Dammam DRT Sustainable Wetlands and Mangrove Conservation (DD-SWAM)

Validation Report

Title of report	Dammam DRT Sustainable Wetlands and Mangrove Conservation (DD-SWAM)
ID of report	CC IPL2100/ICR/VAL/SWAM/20231228
Client (Project proponent)	Saudi Arabian Oil Co. (Saudi Aramco)
Criteria for validation	<input type="checkbox"/> ICR requirement document v.4 <input checked="" type="checkbox"/> ICR requirement document v.5 <input checked="" type="checkbox"/> ISO 14064-2 <input checked="" type="checkbox"/> Applied methodology, CDM Methodology AR- AM0014: Afforestation and reforestation of degraded mangrove habitats v3.0 ¹ <input type="checkbox"/> Other, please specify.
Date of validation	03/01/2024 to 20/04/2024 (Date of on-site inspection to FVR Preparation)
Version number of this validation report	2.1
Date of version	20/04/2024
Prepared by	Carbon Check (India) Private Limited (CC IPL)
Contact	Address: Registered Office: 2071/38, 2nd Floor, Nawala, Karol Bagh, New Delhi - 110005 Corporate off: Unit No. 1701, Logix City Centre Office Tower, Plot No. BW-58, Sector 32 Noida, Uttar Pradesh – 201301, India Telephone: +911204373114 Email: info@carboncheck.co.in URL: www.carboncheck.co.in

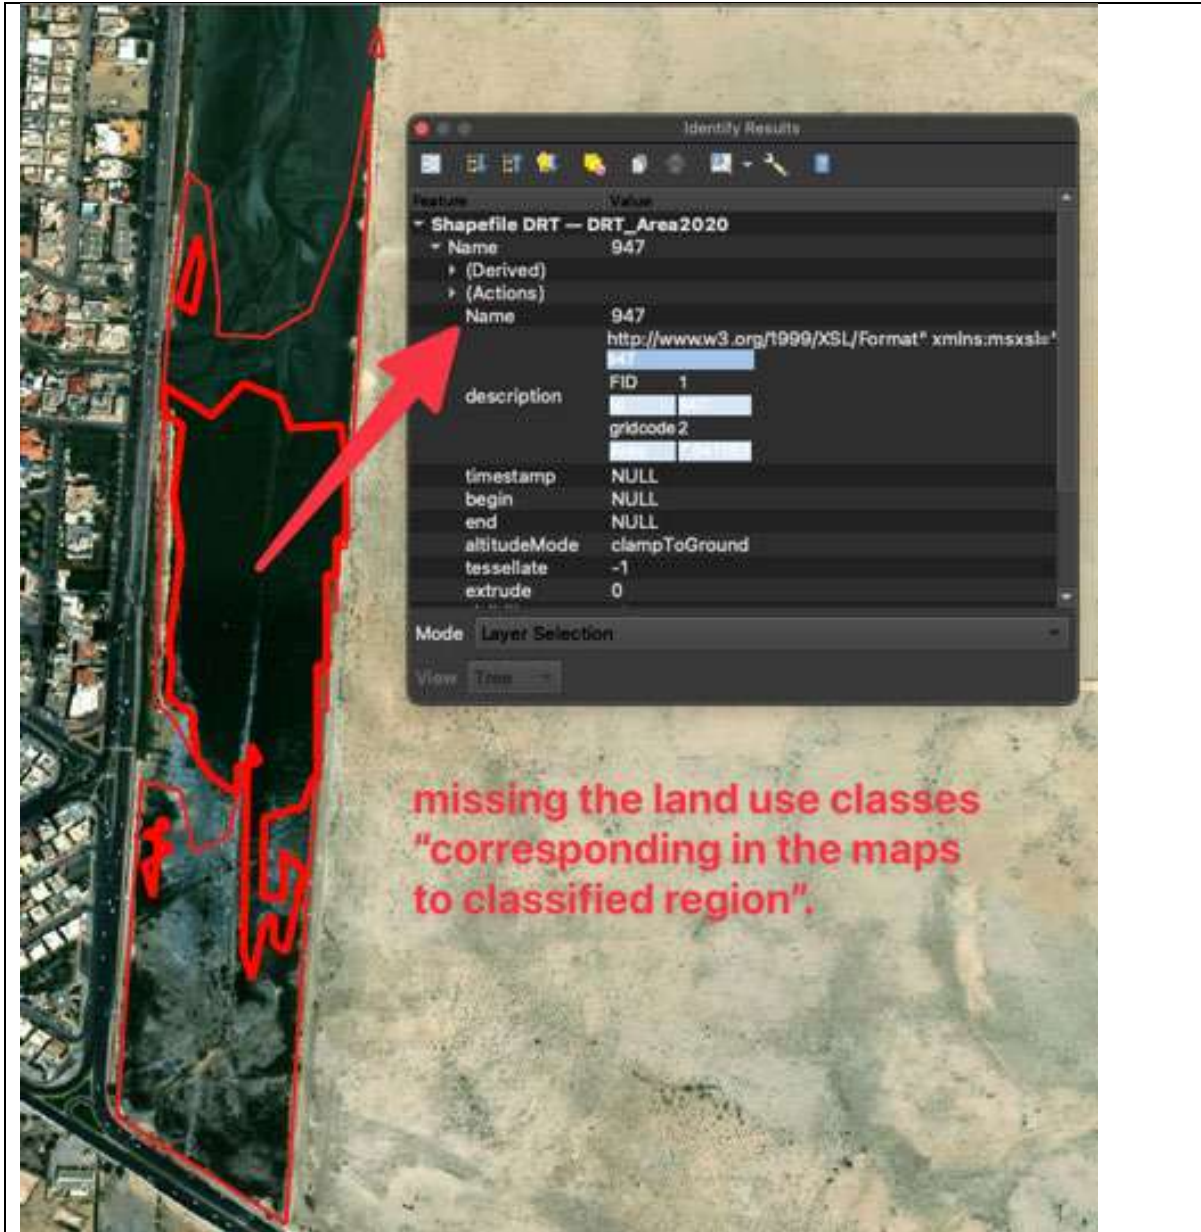
CL	01	Section no.	1.1, ICR PDD	Date: 15 /01/2024
Description of CL				
Documentation provided by project participant:				
<i>DD-SWAM PDD. V1.2.docx</i>				
<i>Dammam DRT.kmz</i>				
The VVB, based on review of files, provide by PP confirms that inconsistencies have been identified:				
<p>1- The files “Dammam DRT.kmz” only have a coordinate of project location additionally mentioned in PDD section 1.3 but doesn’t correspond with the requirements of ICR Requirement Document v5.0, Section 4.2.</p> <p>The PP must define the geographic boundary of the project area to facilitate accurate delineation of project activity instances, furthermore the KML should have a details information as required in concordance with the ICR Requirement Document. While doing so, PP shall demonstrate whether “Ras Tanura Eco Park region” is included in the project region.</p> <p>The illustrative example is depicted in the accompanying figure below as a reference of KML shared by PP.</p> <p>The PP is requested to provide shapefiles/KML files of the project area and planting area.</p>

- Following the requirement of section 4.2 of the ICR Standard v5.0, The project proponent shall provide a detailed description of the geographical boundary of the project activities and the physical location of facilities as applicable to project activities. The physical boundary shall be documented with GPS coordinates. The project proponent shall provide maps, shapefiles, and other relevant information to delineate the project boundary as applicable. PP shall provide respective information in section 1.4 of the ICR PDD.

Project participant response				Date: 13/03/2024
<p>The shapefile is provided, with the boundaries, plantable areas, and existing mangrove areas clearly marked. The Ras Tanura Eco Park region is not included in this project. Any mention of it in the Project Design Document (PDD) is due to a typographical error</p>

Documentation provided by project participant	
<ul style="list-style-type: none"> • DRT Shapefile.kmz (2014) • Shapefile DRT.kmz (2020) 	
VVB assessment	Date: 21/03/2024
<p>While reviewing the KML files provided, VVB has observed that the KML files exhibit inconsistencies detailed as follow:</p> <ol style="list-style-type: none"> The provided KML files exhibit inconsistency in the spatial extensions of 'DRT Shapefile.kmz (2014)' and 'Shapefile DRT.kmz (2020)' differ from each other. Please refer to the figure below for a visual comparison." <p>The difference in spatial extension of both shapefiles represent a difference in total selected area 16.4 ha (DRT 2014) vs 16.9 ha (DRT2020).</p> The KML files provided does not include information on the land use classes “corresponding in the maps to classified region”; Please refer the figure below.

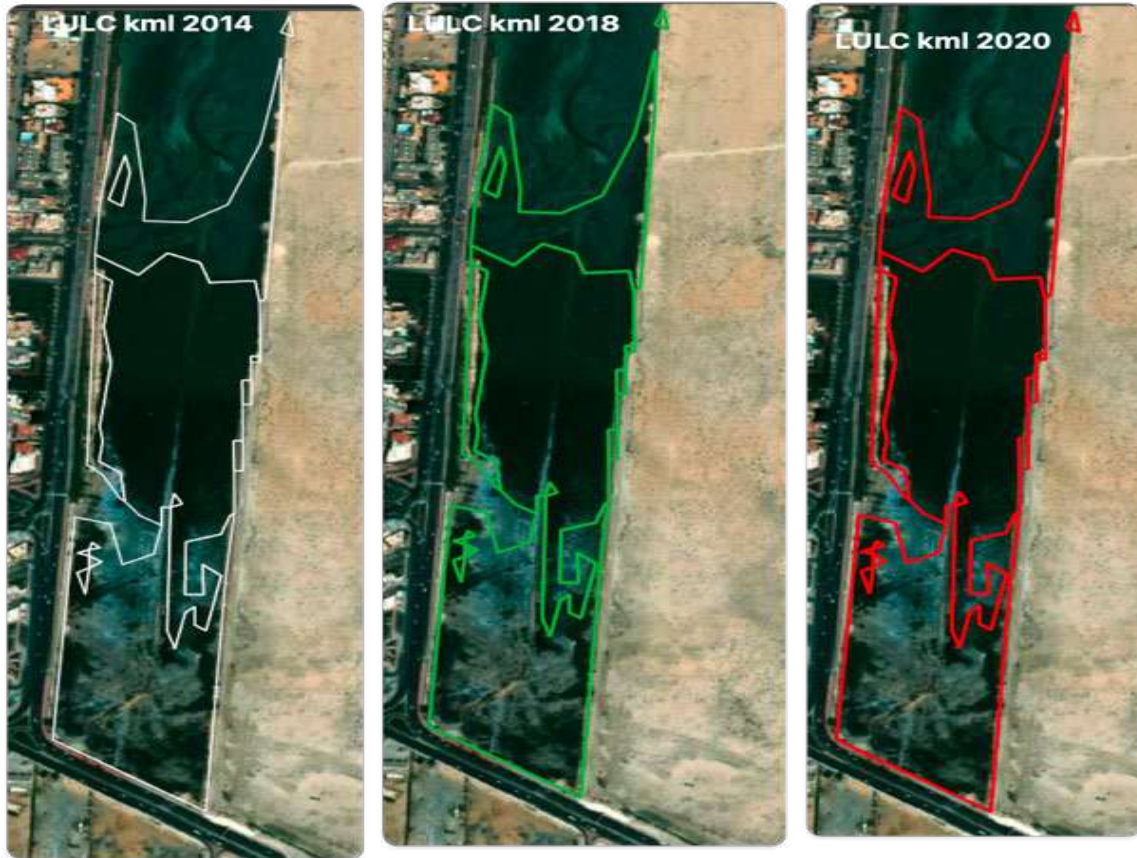
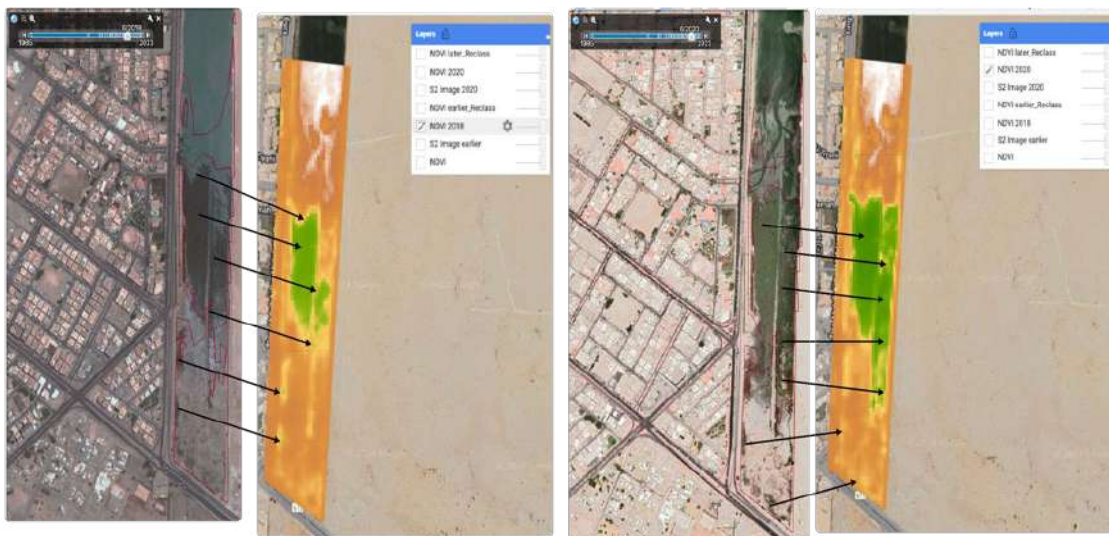
After reviewing the KML files provided by PP, VVB observed that the KML files for LULC 2014-2018-2020 remain

unchanged throughout the analysed period. For a clearer understanding, please refer to the figure below.

However, analysis of the project area, utilizing NDVI calculations derived from Sentinel-2 imagery, reveals a significant change in Mangrove areas between 2018 and 2020. This observation was further corroborated by comparing the NDVI data with corresponding Google Earth images from the same timeframe. Refer to the figure below for visual representation.

<p>PP shall provide supporting document for LULC delineation considering the LULC definition fitted to the project scale. PP must provide LULC satellite image files in easily readable formats, such as GeoTIFF, KML, KMZ, Shapefile, etc.</p> <p>CL is still open.</p>	
Round 3	
Project participant response	Date: 08/04/2024
Documentation provided by project participant	
Revised KML files have been provided.	
VVB assessment	Date: 09/04/2024
<p>VVB based on the review of the revised KML files concludes that the project proponent expects only to restore the degraded mangrove habitat area identified within the project boundary, through plantation activity.</p> <p>To avoid further discrepancy further discrepancy regarding project area and land use cover in current scenario PP has now excluded the area under existing mangrove vegetation from the project boundary and thereby aligns with the ICR guideline and requirement of methodology applied AR-AM0014 (section 2.2.)</p> <p>Based on the review of files and evidence provided by PP, VVB confirms that kml for LULC (2014,2018 & 2020) and the literature provided, are enough evidence to prove the mangrove degradation in and around the project area.</p> <p>VVB confirms that the revised documentation is valid and acceptable for the subject ICR project.</p> <p>The CL has been closed.</p>

Round 2	
Project participant response	Date: 26/03/2024
.kmz files are provided .	
Documentation provided by project participant	
<p><i>DRT AREA 2014 CONVERTED (2).kmz</i></p> <p><i>DRT AREA 2018.kmz</i></p> <p><i>DRT AREA LULC (2).kmz</i></p> <p><i>DRT_2020 copy.jpg</i></p>	
VVB assessment	Date: 26/03/2024

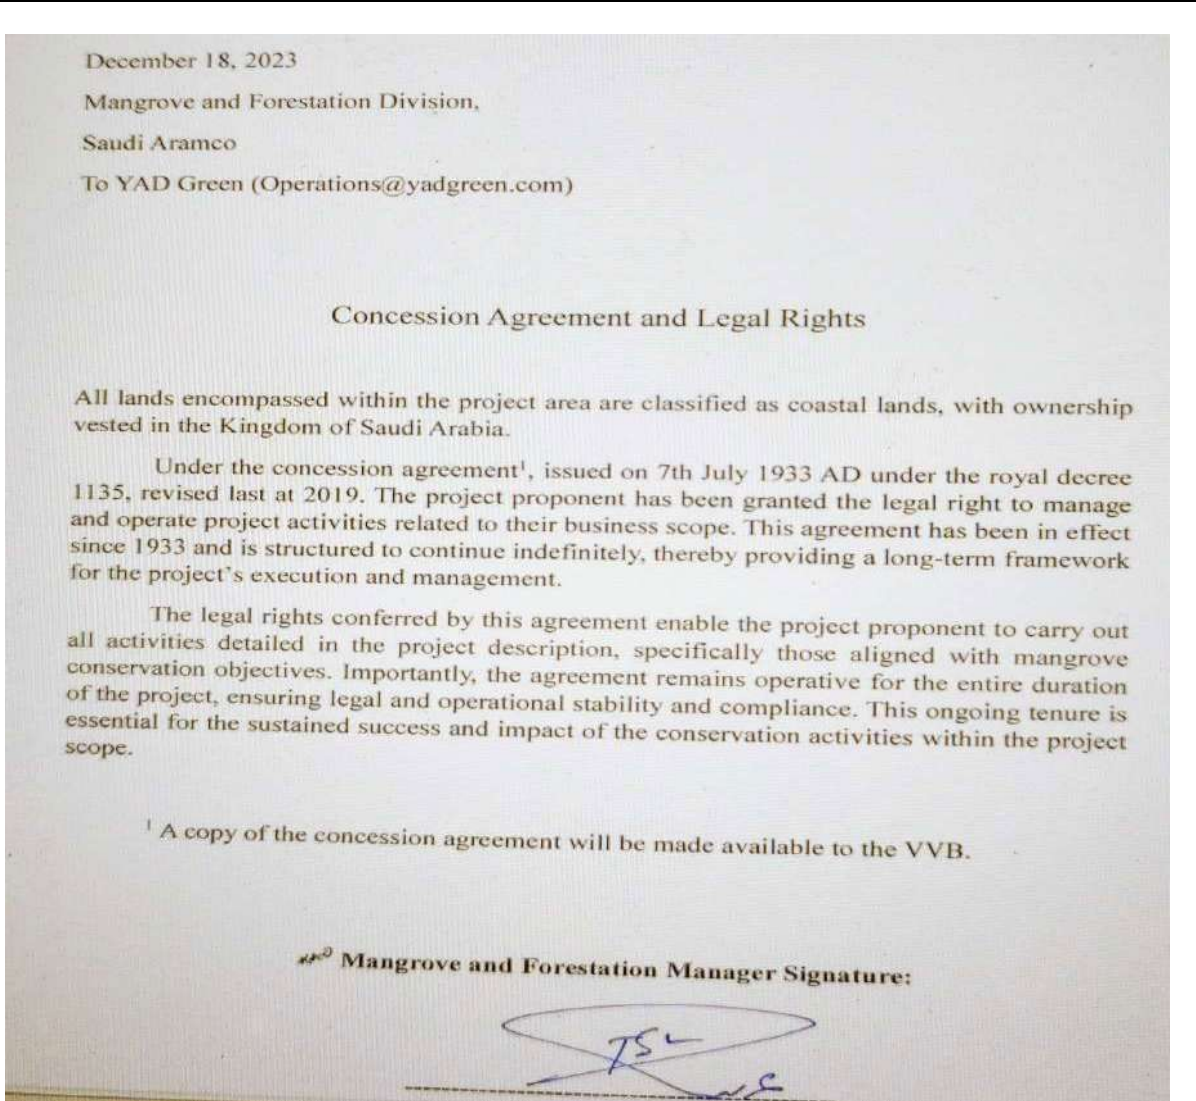
CL	15	Section no.	1.8, ICR PDD (v4.0)	Date: 16/01/2024
Description of CL				
<p>As per section 3.4.2 of the ICR Requirement document, v5.0,</p> <p><i>“Regarding project activities involving CDR, the crediting period is a conservative estimate of the technical lifetime of the installed technologies or implemented measures and associated impacts, with a maximum of 15 years. The crediting period may be renewed at a maximum of twice.”</i></p> <p>However, in section 1.8 of the ICR PDD, the duration of crediting period has been given as 12/01/2024 to 15/04/2053, 30 years. PP shall provide the details in compliance with above requirement i.e., 15 (to be renewed twice)</p>

<p>Furthermore, the frequency of monitoring in the same section has been given as 10 years, which is not in compliance with section 4.10 of the ICR Requirement document v5.0.</p>	
<p>Project participant response</p>	<p>Date: 13/03/2024</p>
<p>The details regarding the crediting period and monitoring frequency have been updated in the Project Design Document (PDD) to ensure compliance with the ICR Requirement Document v5.0. The crediting period now aligns with the stipulated maximum of 15 years, with the option for renewal up to twice, totaling a maximum of 45 years. Additionally, the monitoring frequency has been adjusted to meet the requirements outlined in section 4.10 of the ICR Requirement document.</p>	
<p>Documentation provided by project participant</p>	
<p> </p>	
<p>VVB assessment</p>	<p>Date: 26/03/2024</p>
<p>Based on the review of the ICR PDD, it has been confirmed that the monitoring frequency has been updated to 5 years to align with the ICR requirement. According to the PDD description, project monitoring will commence prior to the project initiation (planting) and will be adjusted every five years from the initial validation. Thereby, VVB confirms that the project follows the ICR guideline for project monitoring as outlined in section 4.10 of the ICR requirement document v5.0.</p> <p>As per the ICR PDD section 2.3 the identified crediting period identified as 15 years, renewable twice, making it a total of 45 years. VVB has reviewed the supporting document to ensure that project activities will be continued over the identified crediting period.</p>

However, PP is requested to provide the concession agreement to confirm the project proponent’s ownership over the subject project area.

Further it is requested to provide adequate evidence demonstrating how project proponent ensure to continue mangrove plantation and its management over the technical life of the proposed ICR project.
